**Comment#74
IEEE P802.3cg/
D1.1
Rosemont, IL**

March 2018

Purpose

Electromagnetic classification 146.7.1.5

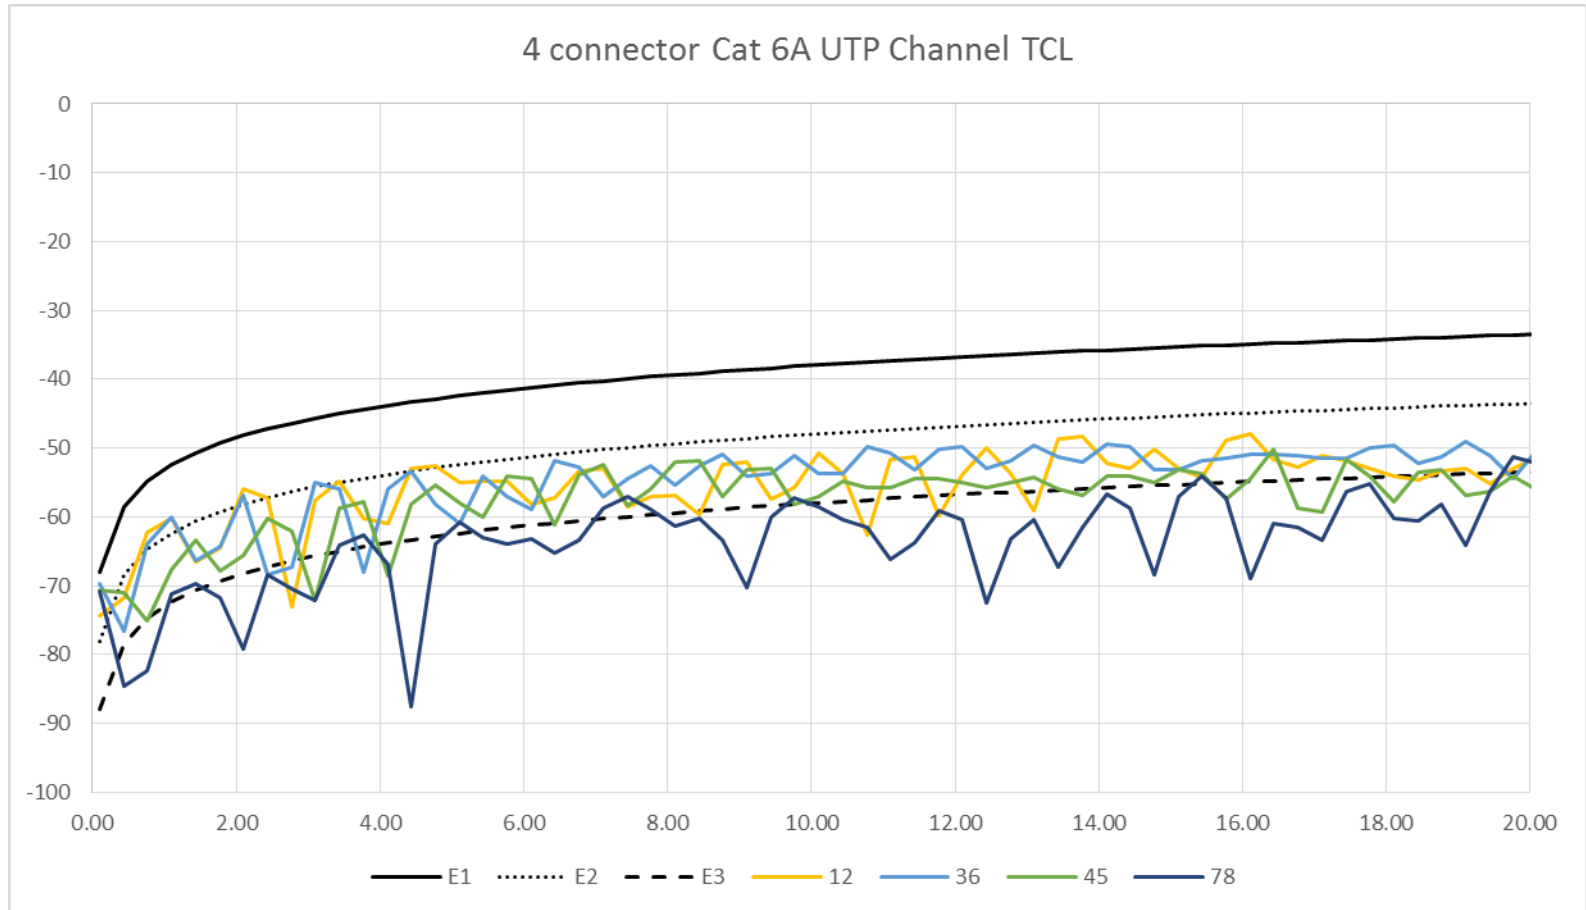
CI 146	SC 146.7.1.4	P 115	L 50	# 74
Schicketanz, Dieter		Reutlingen University		
Comment Type	T	Comment Status	D	Link Segment
editors notes on page 115,118				
<i>SuggestedRemedy</i>				
Delete editors notes and replace Tables 146-5 and 146-6 with the values presented in Schicketanz_122017_10SPE_01_adhoc.pdf pages 7 and 8				
Proposed Response		Response Status	W	
PROPOSED ACCEPT IN PRINCIPLE.				
For committee review of cited presentation.				
http://www.ieee802.org/3/cg/public/adhoc/Schicketanz_122017_10SPE_01_adhoc.pdf

Frequency	E1	E2	E3
TCL	.1 to 20 MHz	53-15lg(f)	63-15lg(f)	73-15lg(f)
ELTCTL	.1 to 20 MHz	30-20lg(f)	40-20lg(f)	50-20lg(f)

TCL measurements

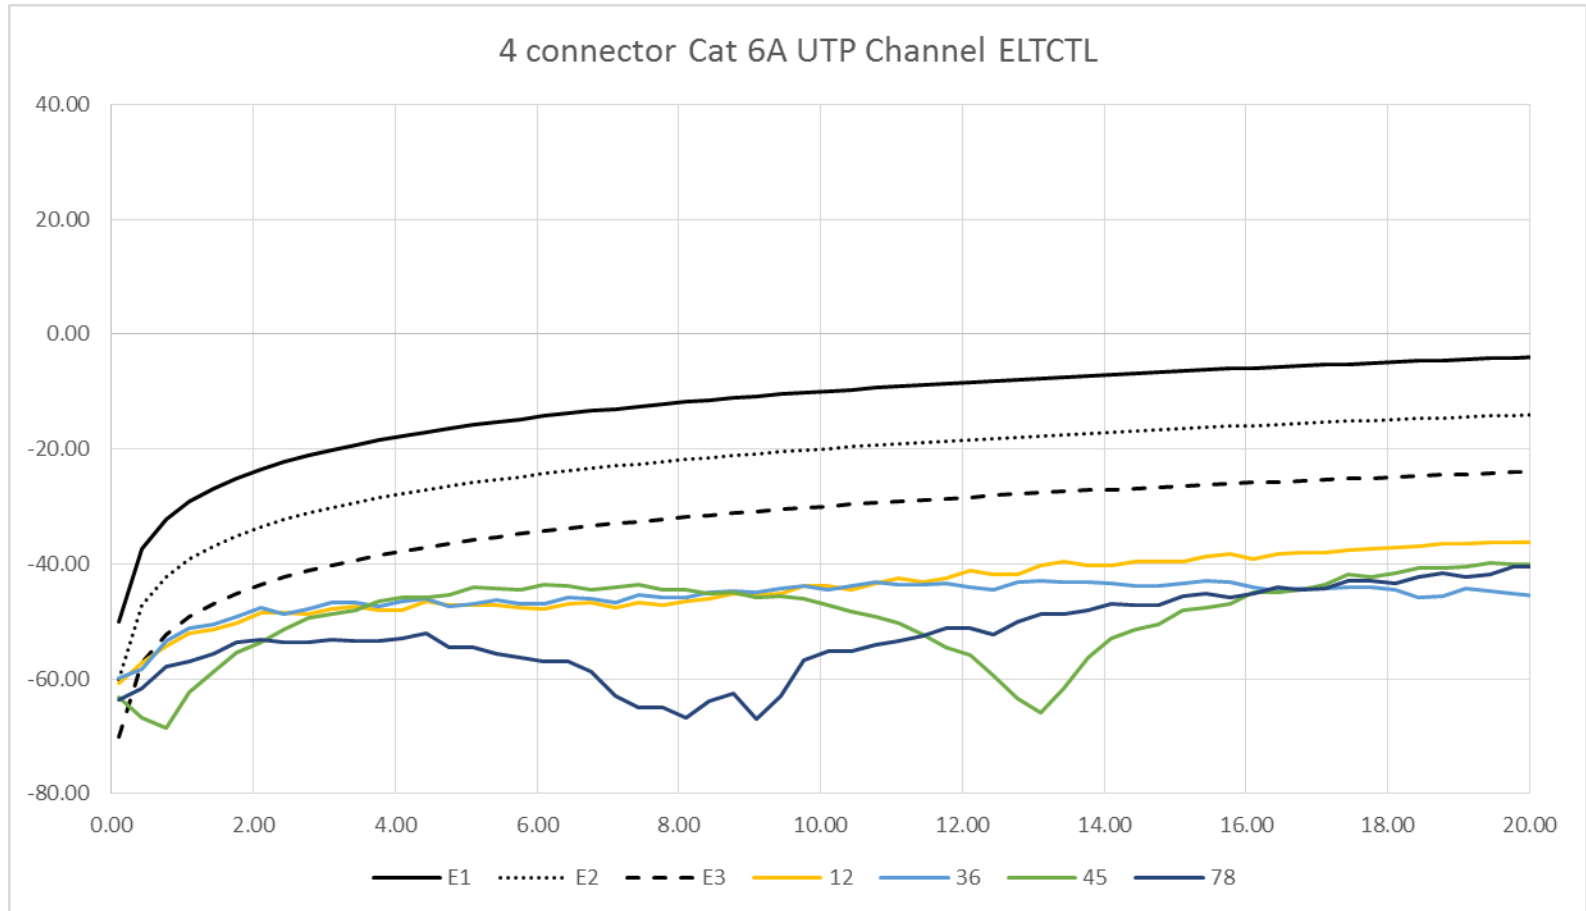
- Provide TCL and ELTCTL measurements and recommendations for Comment#146

TCL measurements

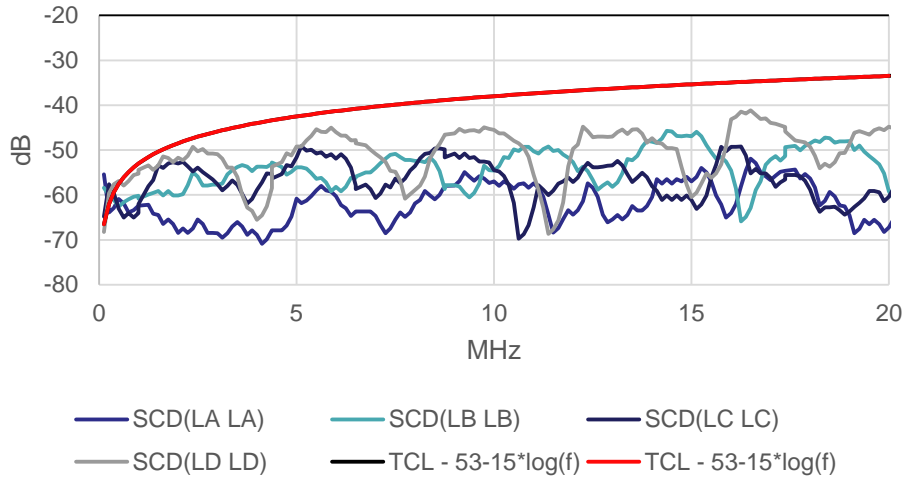
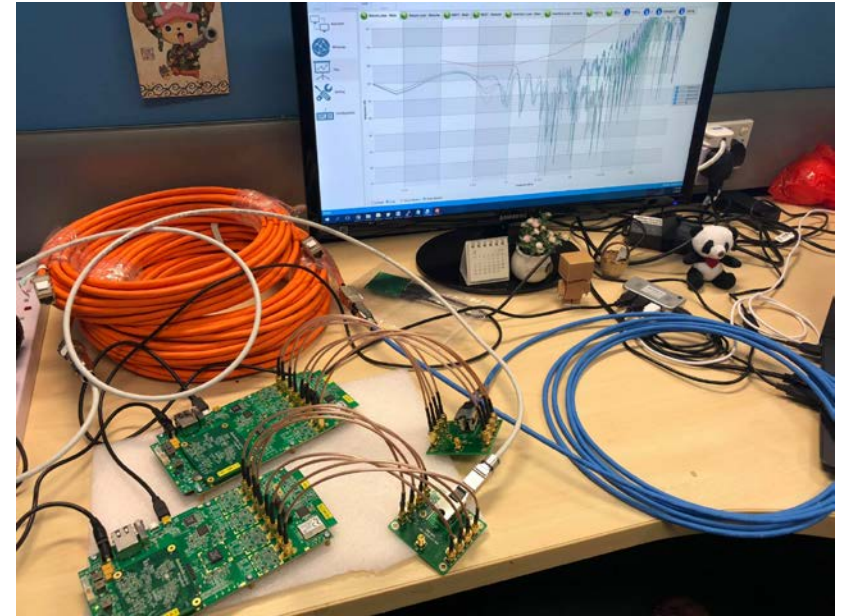
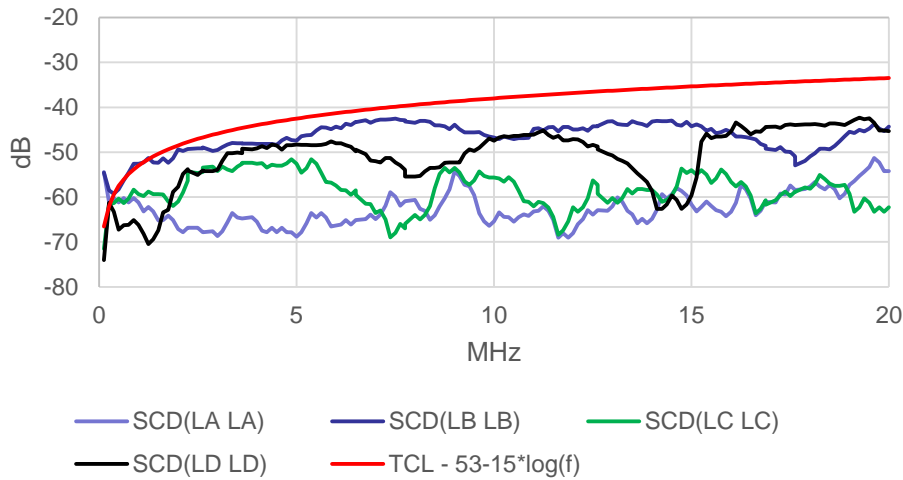
TCL - 2m-30m-5m

TCL-2m-15m-5m

ELTCTL measurements

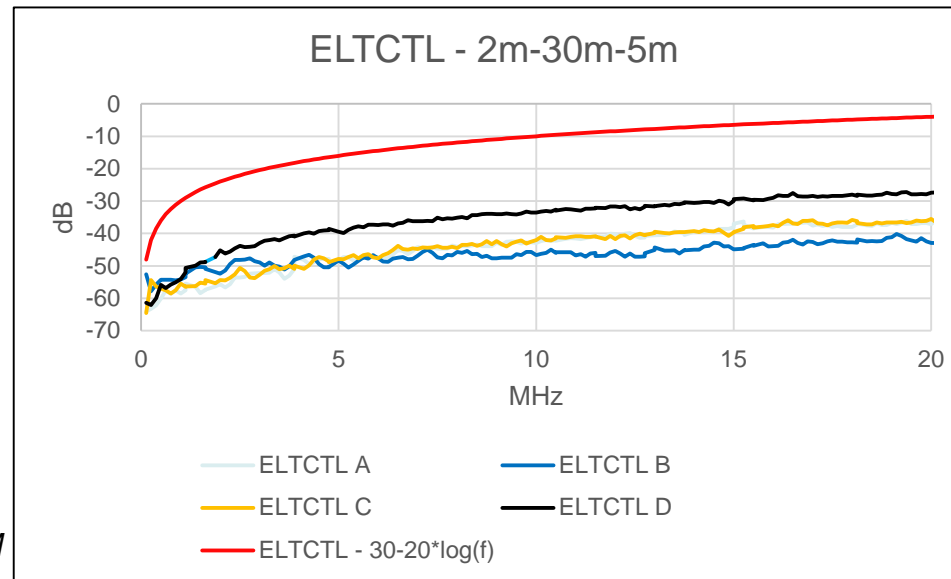
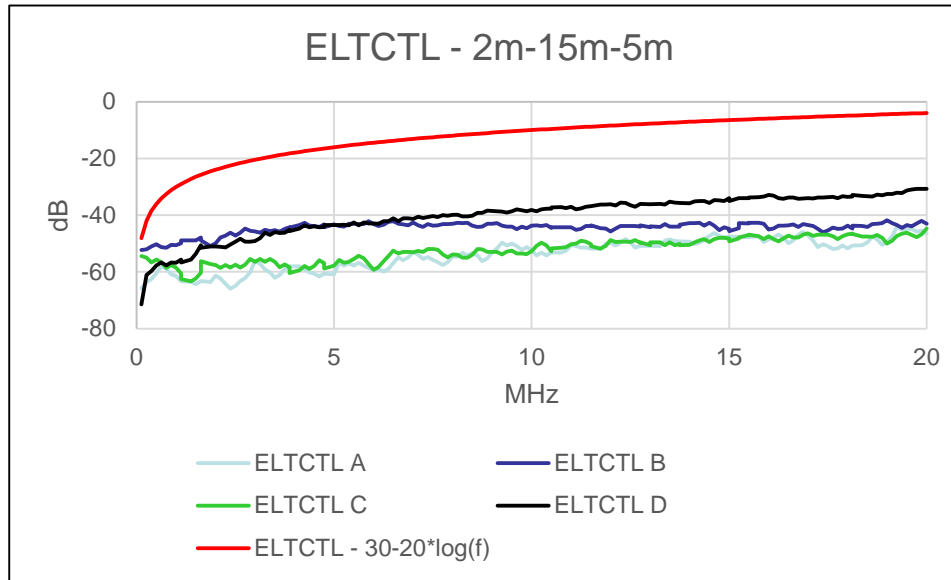
Source: Arvind Patel, AEM
